DESERT TORTOISE COUNCIL

December 19, 2024

Re: Copper Rays Solar Project (DOI-BLM-NV-S030-2022-0009-EIS)

Figure 3 (as cited in the DEIS). Map of solar projects in the Pahrump Valley area.

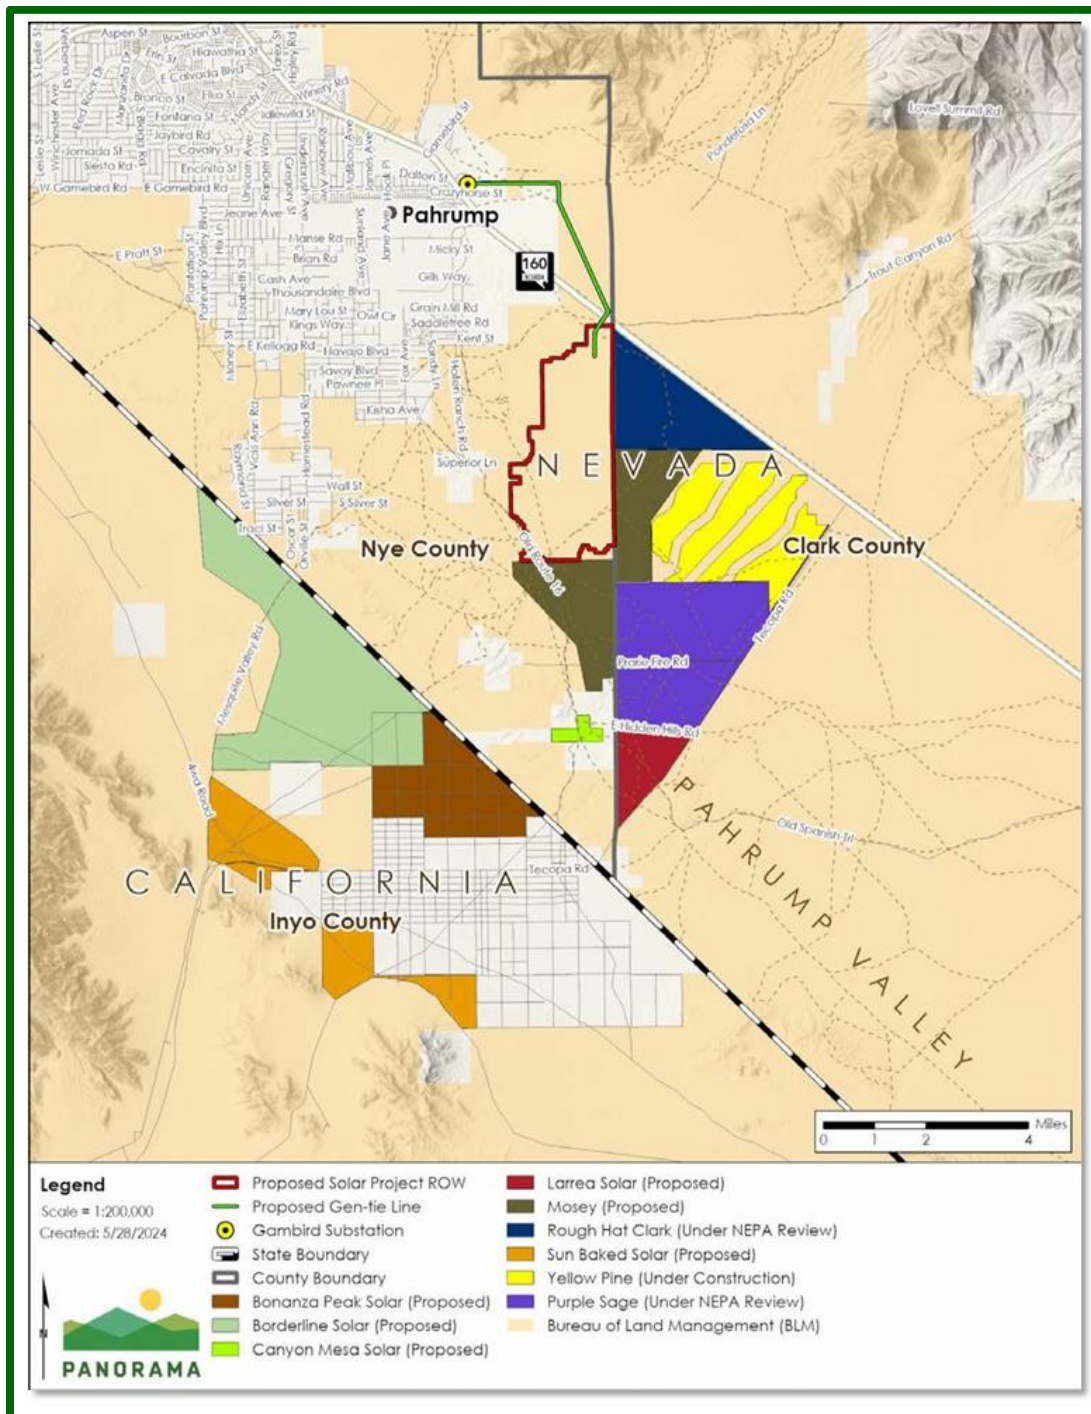
Parandhaman’s research (2023) revealed the importance of valleys in southern Nevada in providing habitat for the tortoise in response to climate change now and in the future. There are several existing and proposed projects in the Pahrump and Ivanpah Valley area (Figure 3) that when implemented would impede the ability of the tortoise to move north in response to climate change. In the DEIS, BLM lists 24 projects as past, present, and reasonably foreseeable future actions. These projects total more than 39,000 acres of direct impacts with additional indirect and cumulative impacts. Given Parandhaman’s research on the impacts of climate change, this improvement to the north-south connectivity of the tortoise in this Valley with access to valleys farther north should be implemented. BLM should use the best available scientific information to determine the current and future needs of the tortoise in the Indian Springs Valley to provide and manage for effective linkage habitat between the Eastern and Northeastern Mojave Recovery Units and valleys to the north.

We ask that the DEIS be augmented so that the final environmental impact statement (FEIS) documents the number and configuration of acres that have been converted to solar development and the number of tortoises that have been displaced from the Pahrump Valley as the result of BLM’s approvals, which have “...no acreage threshold for habitat lost to solar.” To respond to this request, we ask that a table like Table 3.1-3 Past, Present, and Reasonably Foreseeable Future Actions within the Cumulative Effects Analysis Area on pages 3.1-9 and 3.1-12 be populated with the numbers of acres and tortoises that have been and would be displaced by these 24 tabulated projects along with their impacts on the ability of the tortoise to move north through the Pahrump Valley in response to climate change.

We feel that it is short-sighted of the BLM to fail to identify an “...acreage threshold for habitat lost to solar” in the Pahrump Valley along with avoidance areas to provide effective linkage habitats north through the Ivanpah and Pahrump Valleys so the tortoise may use these habitats to respond to climate change, which need to be determined to ensure that tortoises are not extirpated by direct, indirect, synergistic, and cumulative impacts in the valley.

Figure 1 (as cited in the DEIS). Live tortoise survey results.

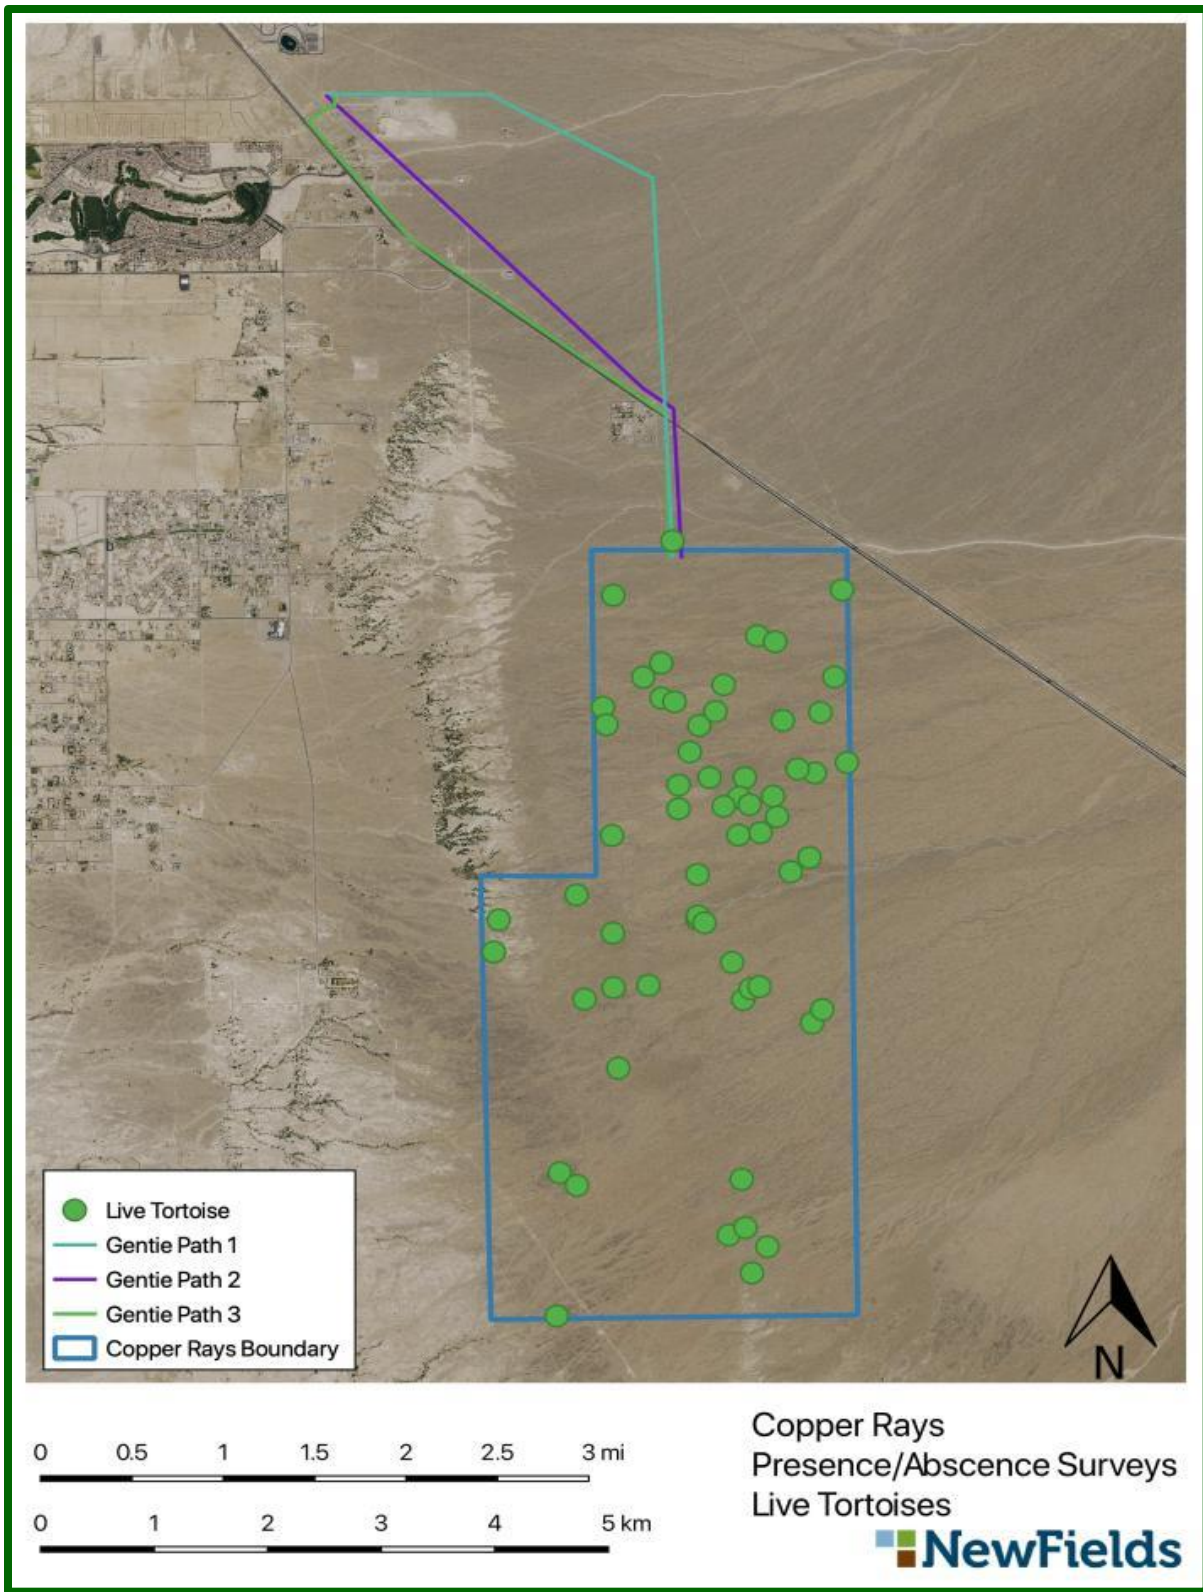
According to the BLM’s quoted statement on October 24, 2024 during the Zoom meeting, an estimated 121 tortoises would be lost from these intact habitats, where 61 live adult tortoises were found (Figure 1). According to the supplemental information provided by BLM on their National Environmental Policy Act (NEPA) ePlanning webpage for the Copper Rays Solar Project, the estimated number of adult tortoises throughout the project sites was calculated to be 137, with a 95% confidence interval of 55 to 344 adult tortoises. This estimate does not include the number of hatchling, juvenile, or immature tortoises that occur in the action area (Newfields 2021). The amount of tortoise sign that was found at the Project site covers the entire site (Figure 2), which indicates that tortoises are actively using and have recently used the entire site.

The density and distribution of tortoises and the amount of tortoise sign on this proposed site clearly reflects “intact, functioning landscapes,” which is the first of the three primary ways in which the BLM’s Conservation and Landscape Health Rule is intended to protect. As given in Table 1-1 at the bottom of page 1-7, we see that the project is proposed “...within a Priority 2 Connectivity Area identified by the USFWS, *which is an area of contiguous, high-quality habitat that provides connectivity for desert tortoise populations* [emphasis added].” The FEIS needs to clearly document why BLM is willing to violate this Health Rule, FLPMA, and other BLM regulations by allowing the proponent to develop this site in a healthy, functioning tortoise population located in important connectivity habitat.
